# 8. Engagement & Consultation

# **Pre-App 2: Design & Feedback** December 2020

# **Pre-App 2: Design & Feedback** December 2020

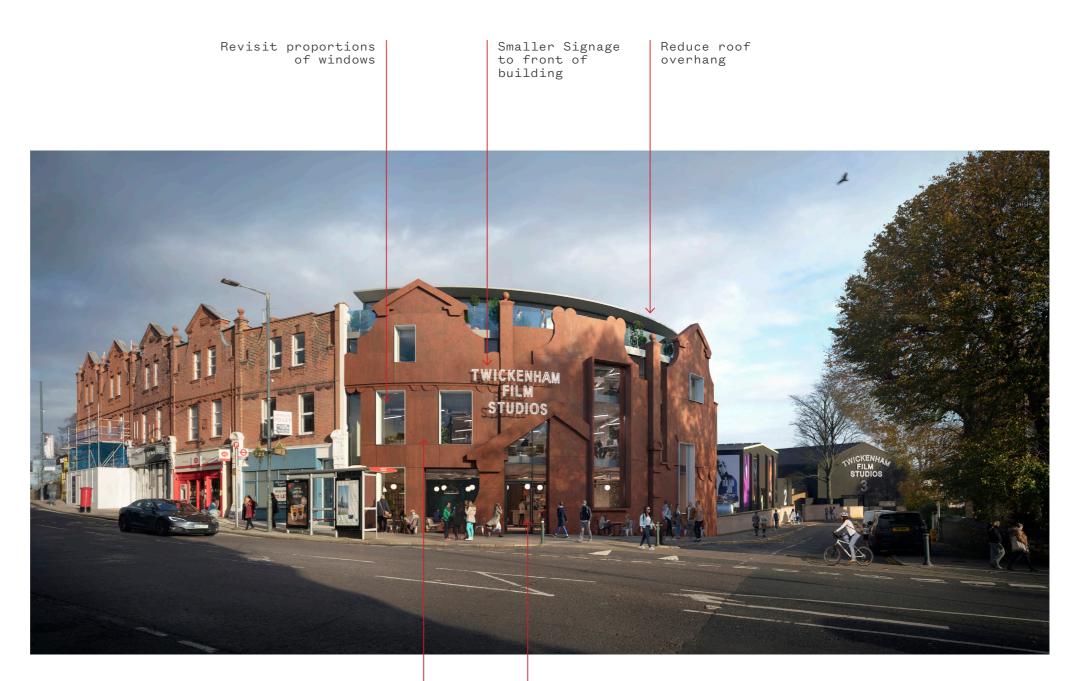
- The scheme needs to be unified as a whole, with an overarching concept tying the buildings together.
- The existing boundary wall needs to be explored further. It could be used to unify the scheme, perhaps through mural art or signage to celebrate the history of the site and/or to tell a story.

- Having more fun with interventions across site is key. This could be done by translating the playful language used for Block A across the site.
- The graphic signage could also tie the entire scheme together, this needs to be celebrated more across the site.

- How does the scheme relate to the street and public realm as this will inform how the proposal forms part of the street scape and how the public perceives the buildings from the street.

- The spaces in between the buildings need to be made more coherent. This can be done through landscape design and treatment of surfaces to upgrade the existing condition and help formulate a journey through the site. The sustainability principles could be developed further to reflect the potential usage within the buildings.

Relationship to public realm

Signage

### Block C

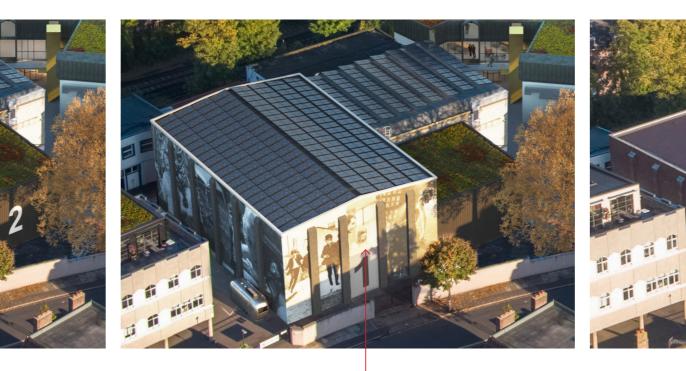
- The use of historical images is much more appropriate than the use of current film posters.
- Graphic signage similar to the other blocks should be incorporated here to include words ('Studio 1').
- An option without the historic images could also be explored, as the graphic signage could be a strong enough concept on its own and relate throughout the site as way finding.

Historic imagery is more appropriate

Less appropriate to use current film posters here

#### Explore 'Studio 1' signage

Explore red brick option
